MONTGOMERY COUNTY HISTORIC PRESERVATION COMMISSION
STAFF REPORT

Address:	7200 Maple Ave., Takoma Park	Meeting Date:	3/23/2022
Resource:	Outstanding Resource Takoma Park Historic District	Report Date:	3/16/2022
Applicant:	Elizabeth Baer & Daniel Eichner Richard Vitullo, Architect	Public Notice:	3/9/2022
Review:	HAWP	Tax Credit:	n/a
Permit No.:	982698	Staff:	Dan Bruechert
Proposal:	Building addition, areaway, and hardscape alteration

Figure 2: 1927 Sanborn Fire Insurance Map showing the subject property (note the sunporch was open during this period).

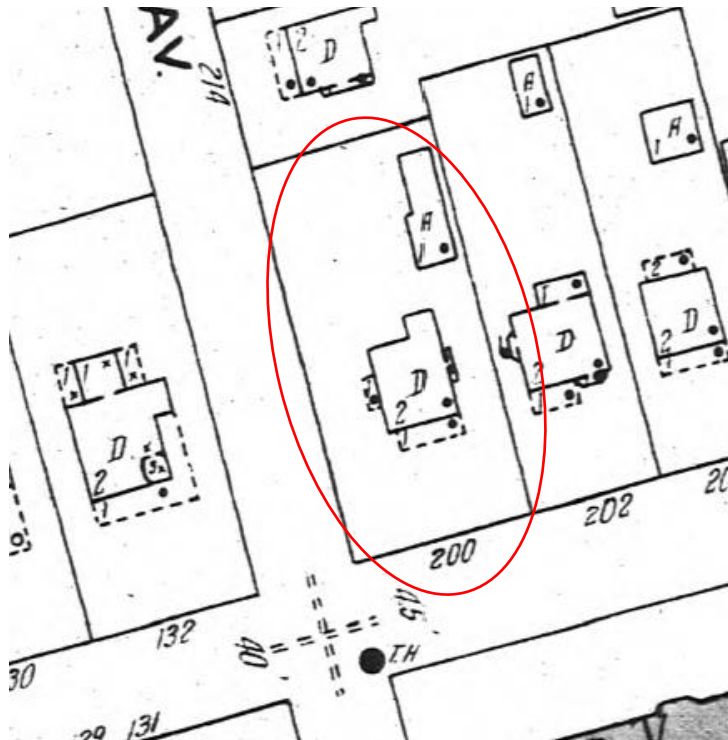
The subject property is a two-story Craftsman with a parged concrete foundation and wood siding with a gable roof. The house has Maple Ave. address, but is oriented towards Tulip Ave. The rear of the house has a deck, with a first-floor bump-out, and an enclosed sleeping porch on the second floor. Notes included in the historic district survey state it is significant for "bldg form: sunporch in front, side portico." The Sanborn Map shows the enclosed sun porch was open in 1927 and the property had a significant accessory structure to the rear.

Figure 3: Tulip Ave. elevation of the historic house (right) and the proposed addition and porch (left).

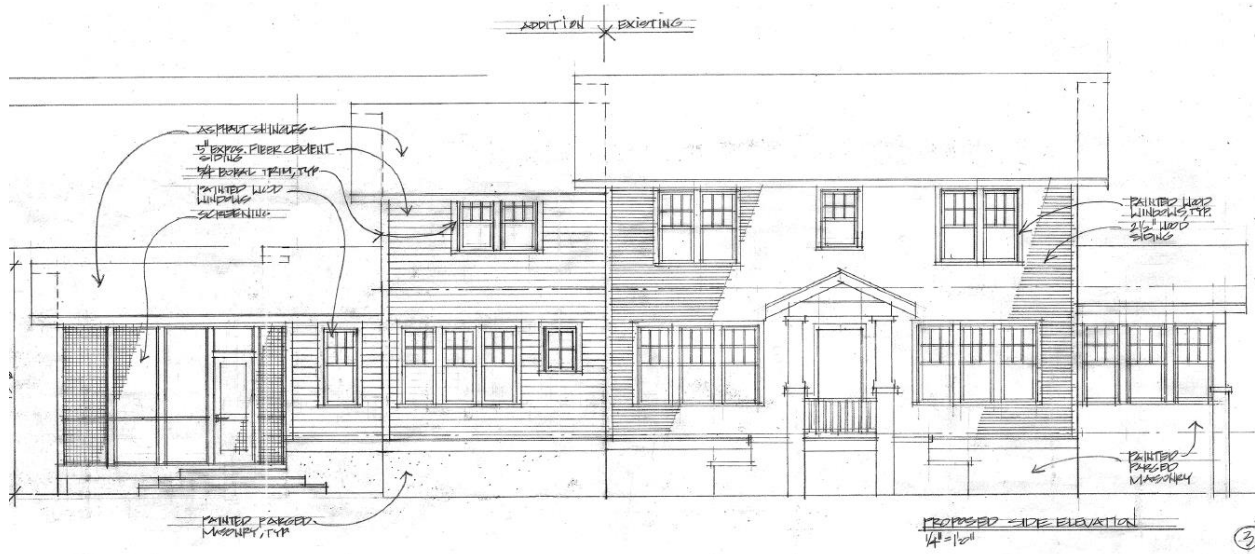
Staff finds that the proposed addition will be in a highly visible location, however, because the house is on a corner lot and the proximity to the 7' (seven-foot) setback line, Staff finds the addition could not be located anywhere else on site. While the *Design Guidelines* state additions should be placed to the rear of the house to minimize the addition's visibility, there is no feasible location that would be less visible. Staff finds the location of the proposed addition is appropriate.

The footprint of the proposed addition is approximately 1/3 of the historic house. Staff finds that this is approximately the maximum size an addition to this house could be while satisfying Standard 9. Another factor in favor of the appropriateness of the proposed addition is the addition's roof ridge is 1' 9" (one foot, nine inches) lower than the historic roof ridge. Finally, the front wall plane of the proposed addition is set back from the historic wall plane by 4' 6" (four feet, six inches), this allows the historic house to retain its primacy on site. Staff finds these dimensions create an addition that is subservient to the historic resource in its size, scale, and massing as required by the *Design Guidelines* and Standard 9.

The siding proposed for the addition is fiber cement clapboards in a 5" (five-inch) reveal. This contrasts with the historic wood siding that is a much narrower 2 1/2" (two and a half inch) reveal. Windows in the proposed addition are a mix of wood double-hung sash (6/1) and wood casement windows. The proposed foundation is parged CMU, which will mimic the appearance of the existing painted masonry foundation in the historic house. Staff finds the proposed materials are compatible with the historic house and are appropriate substitutes that will sufficiently differentiate the proposed addition from the historic construction (per Standard 9 and the *Design Guidelines*)
